DATE: January 31, 2018

AGENDA ITEM # 2

TO: Design Review Commission
FROM: Steve Golden, Senior Planner
SUBJECT: 17-V-07 and 17-SC-28 – 2046 Kent Drive

2046 Kent Ridgeline height to existing slab is actually (dwg. A10,A8,A7,A7A)

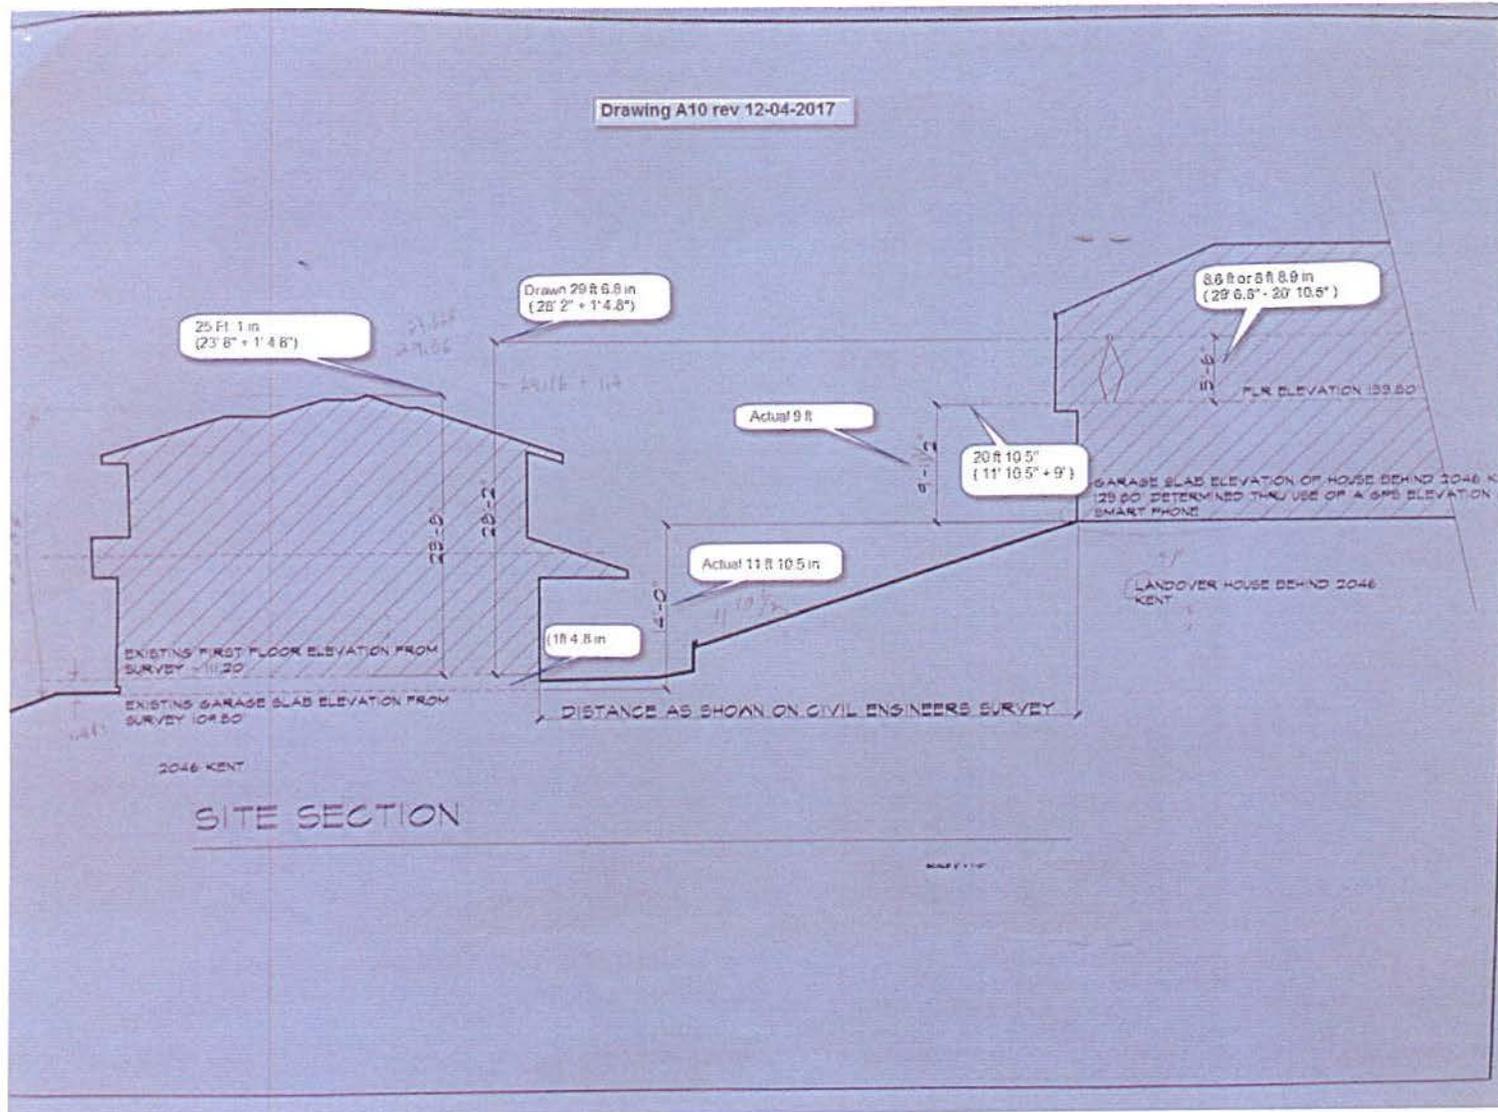
Resulting Impact is the 2046 Kent slab to Andover 2nd floor elevation is significantly in error 20 ft. - 10.5 in vs 23 ft.- 11.5 in (difference of 3 ft. – 1.5 in.)

- 1st floor to slab elevation height not used for ridge height under valuing by 1.4 ft. (1 ft. 4.8 in.)
- The height 2046 Kent slab to 1st floor 1.4ft (1Ft 5in) not in 23ft 8 in ridgeline calculation
- **Bottom line: Actual slab to ridgeline is 25 Ft**

Family room view impact - Superimposed Drawing from uphill 974 Andover Way

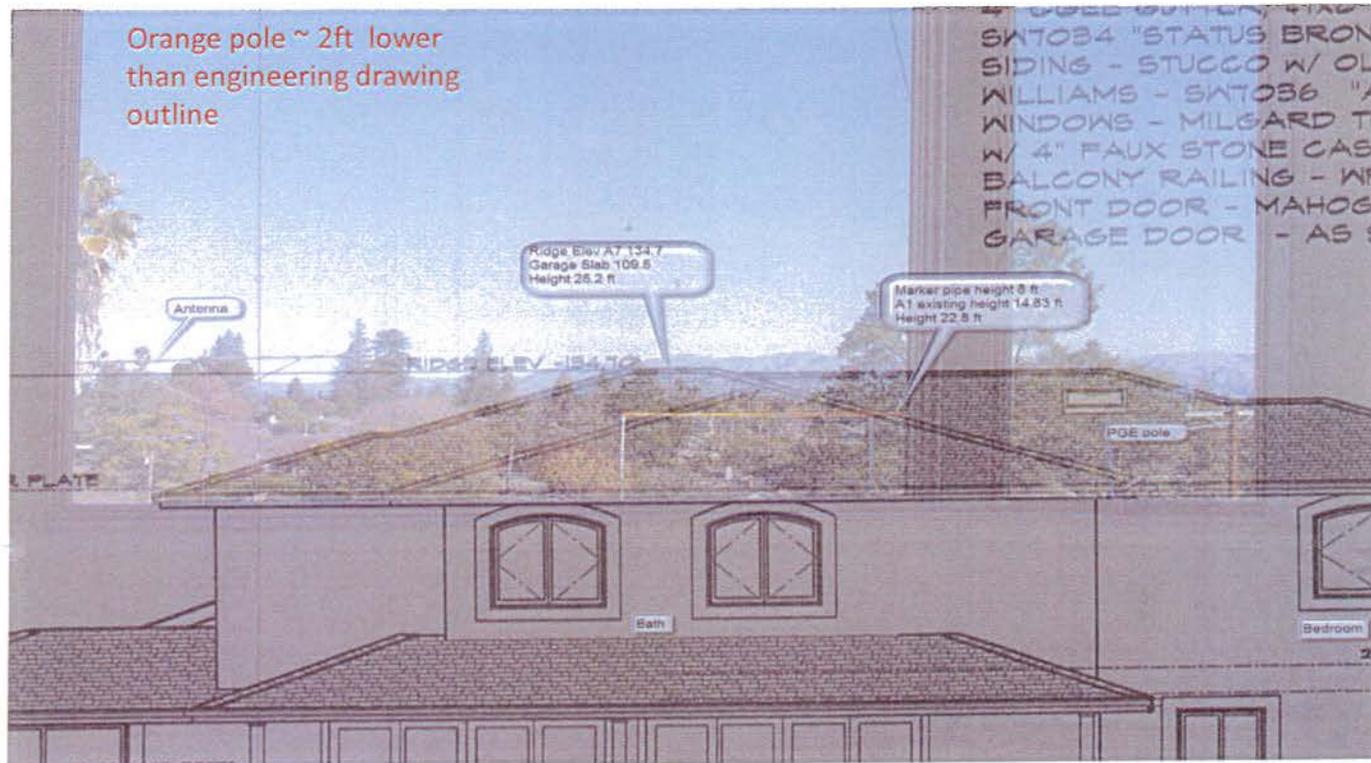
- Near field view impact significant
- Orange Post aided ridgeline photo alignment - bay window to A7 drawing
- Ridgeline height (~25ft) is closer to antenna than orange outline pipes

Deck View - Superimposed Drawing

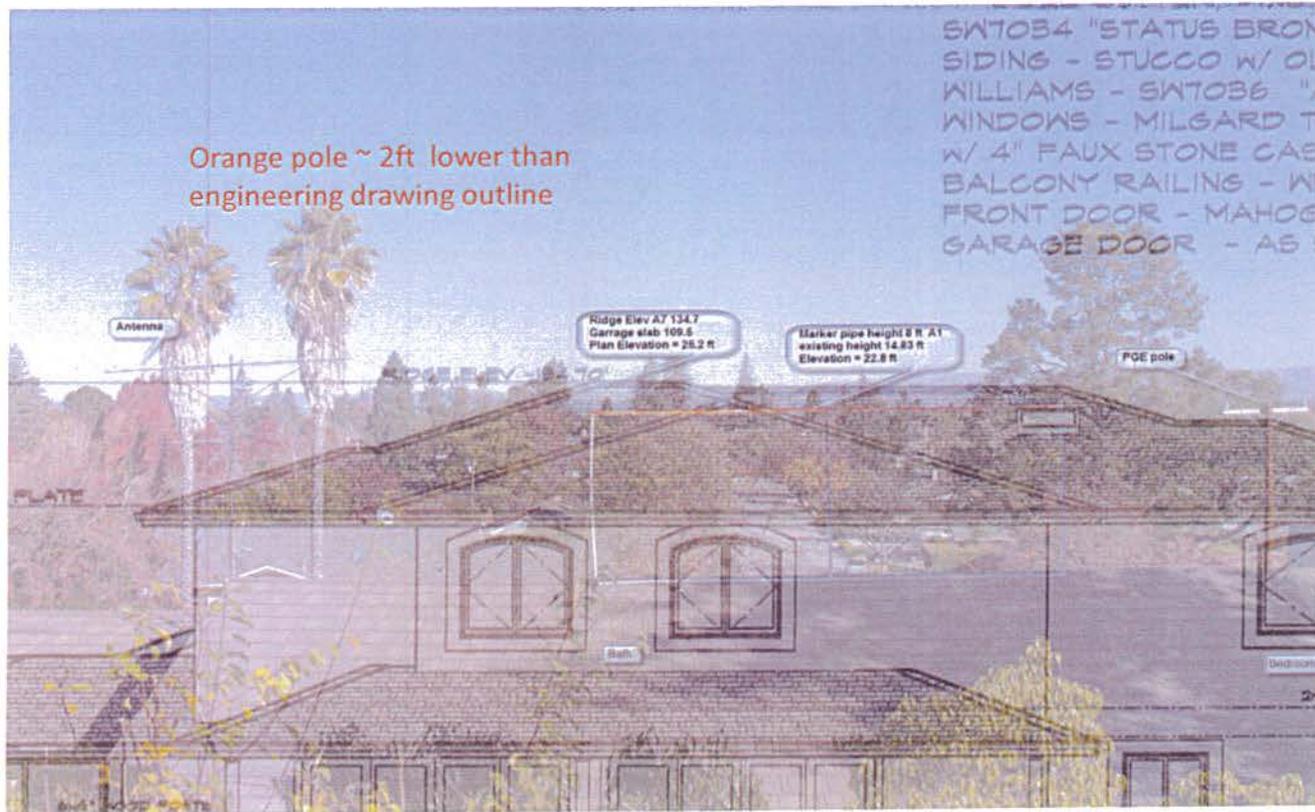
- Greater impact to deck & rear yard
- Deck is 8 inches (3/4 ft.) lower than Family room floor
- Orange post aided ridgeline photo alignment - bay window to A7 drawing
- Ridgeline height (~25ft) is closer to antenna than orange outline pipes

Scott Lane View looking up to 2046 Kent Drive

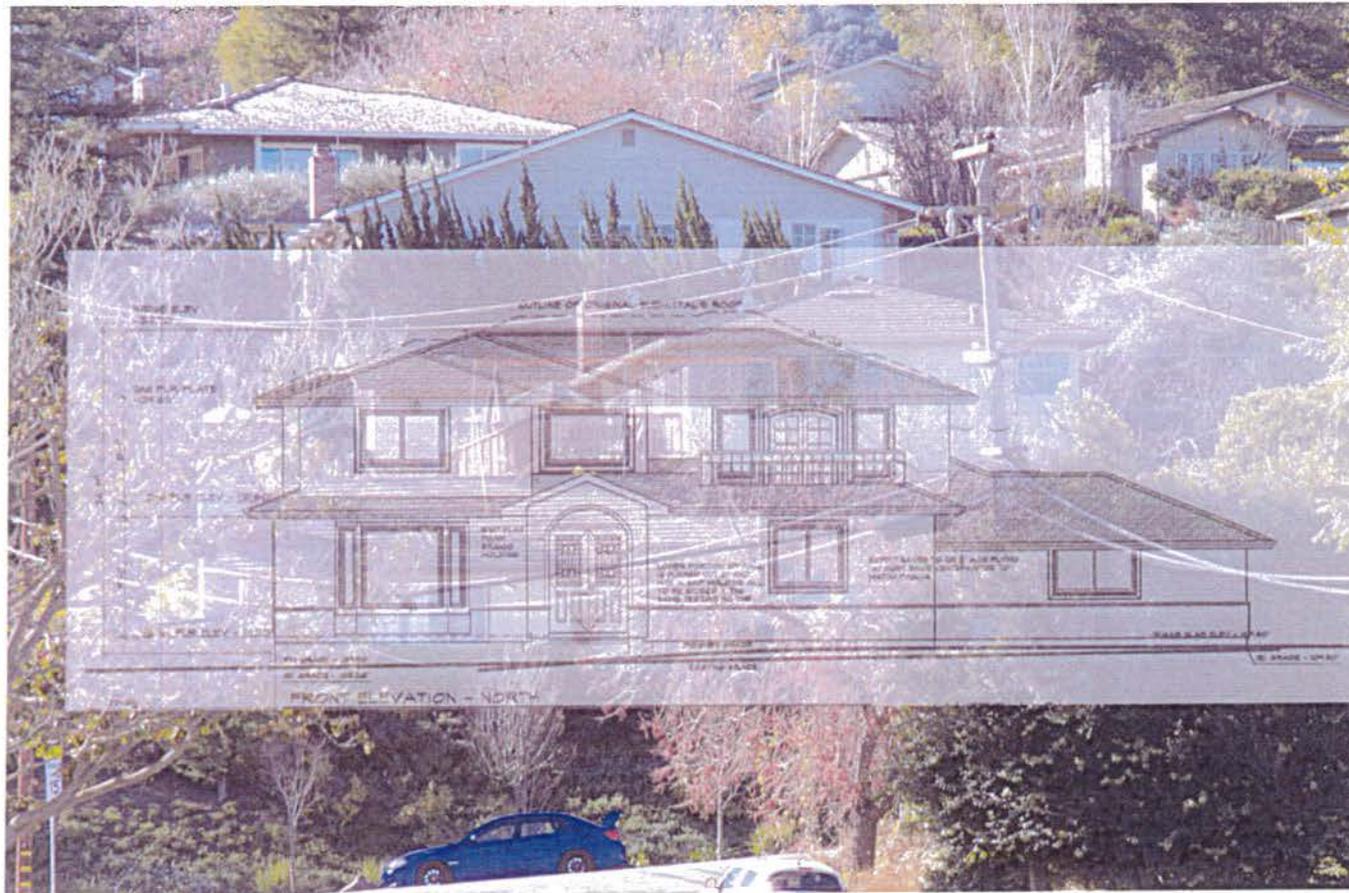
- Uphill 2nd story development changes neighborhood view lots
 - A concern of the neighbors that we talked to
- 41ft ridge line dominates Scott Lane & Kent Drive intersection
